Amendments to the Drawings:

This application has been reviewed carefully in light of the Office Action mailed March 5, 2009. The specification was objected to as failing to provide proper antecedent basis for the claimed subject matter. Claims 13
5 and 14 were objected to for informalities. Claims 16-17 were rejected under 35 U.S.C. § 112, second paragraph, as being indefinite.

Figure A

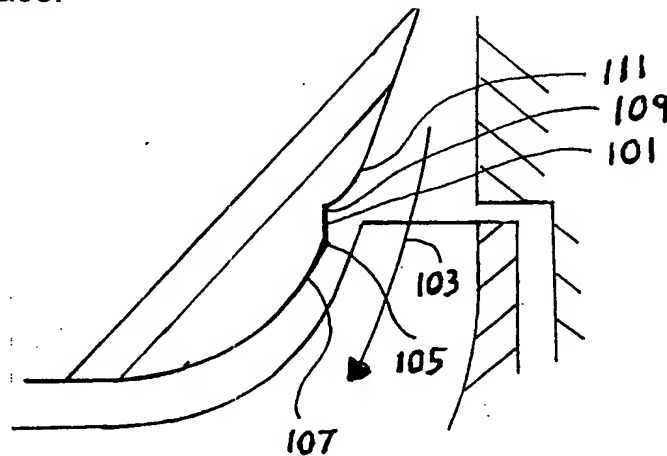
Claims 16 and 17 have now been amended. In figure A, below, the applicant depicts a discontinuity under claims 1 and 16 and 17 at the trailing edge of a blade. The discontinuity shown is the one depicted in Fig. 4d of the application.

Per the last clause of claim 1, figure A depicts a discontinuity forming a downstream-facing blocking face 101 adapted to impede an upstream flow of gas between the shroud and the wheel, the blocking face extending across the gas flow path to form a sharp edge 105 connecting the blocking face to a smoothly curving surface 107 along the gas flow path upstream of the blocking face (i.e., upstream of the discontinuity).

Per claims 16 the blocking face 101 forms a second sharp edge 109 on an opposite side (i.e., a downstream side) of the blocking face 101 from the first sharp edge 105, the second sharp edge 109 connecting the blocking face 101 to a second smoothly curving surface 111 that is downstream of the blocking face (i.e., downstream of the discontinuity).

In claim 4, the above-described (first) discontinuity is differentiated from a second discontinuity (not shown below). In similar form to claims 16, claim 17 (which depends from claim 4) recites that the first-discontinuity blocking face 101 forms a second sharp edge 109 on an opposite side (i.e., a downstream side) of the first-discontinuity blocking face 101 from the first sharp edge 105 of the first-discontinuity blocking face 101, the second sharp edge 109 connecting the first-discontinuity blocking face 101 to a

In light of the amendments and the preceding discussion, the applicant respectfully requests the rejection of claims 16 and 17 under 35 U.S.C. § 112, be withdrawn.

Figure B

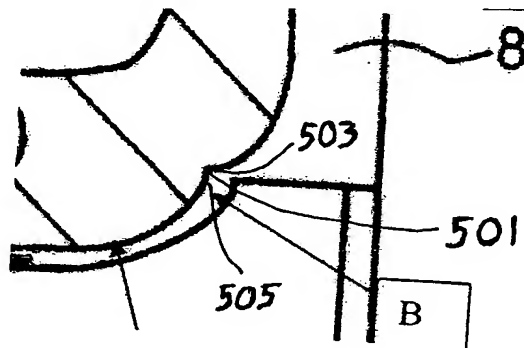
The applicant notes with appreciation the figures incorporated into the Office Action, which clarify the related discussion. The drawing from Mitsubori et al., as shown on page 9 of the Office Action, is replicated in part below as Figure B, with additional notations. In the drawing, the depicted discontinuity is made of a dimple having a single sharp edge 501 at the base of the dimple, an upstream-facing face 503 downstream of the sharp edge, and a downstream-facing face 505 upstream of the sharp edge. Mitsubori et al. fails to disclose a sharp edge connecting a downstream-facing blocking face to a smoothly curving surface upstream of the blocking face.

Because the cited reference fails to disclose the features of claim 1, 15/1 and 18, the Office Action fails to assert a prima facie case of anticipation, and the applicant respectfully requests the rejections of claims 1, 15/1, and 18 under 35 U.S.C. § 102(b) be withdrawn.

Figure D: Fabri et al.

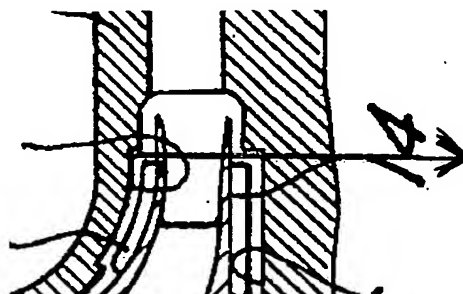
25 The Fabri et al. patent clearly fails to disclose a sharp edge that connects a downstream-facing blocking face to a smoothly curving surface upstream of the blocking face. While it is not entirely clear which sharp edge is identified in Fabri et al., there is no sharp edge that connects a smoothly curving surface on the upstream side of the edge to a face that points at all downstream by any reasonable definition.

The Office Action recites that both Yoshinaga et al. and Fabri et al. disclose downstream facing faces, and notes that during examination
5 claims must be interpreted as broadly as their terms reasonably allow. Portions of the figures identified in the Office Action are reproduced below, with lines added showing the direction that walls in the vicinity of the trailing edges are facing. In each case these walls are facing directly across the
10 flow. There is no portion of the passageway that is angled to suggest that the wall is in a downstream-facing direction. Thus the applicant respectfully notes that there is no reasonable interpretation of the term downstream-facing face that applies to these figures.

Because the cited references fail to disclose a downstream-facing blocking face, the applicant respectfully requests the rejections of claims under Grounds 2-6 be withdrawn.
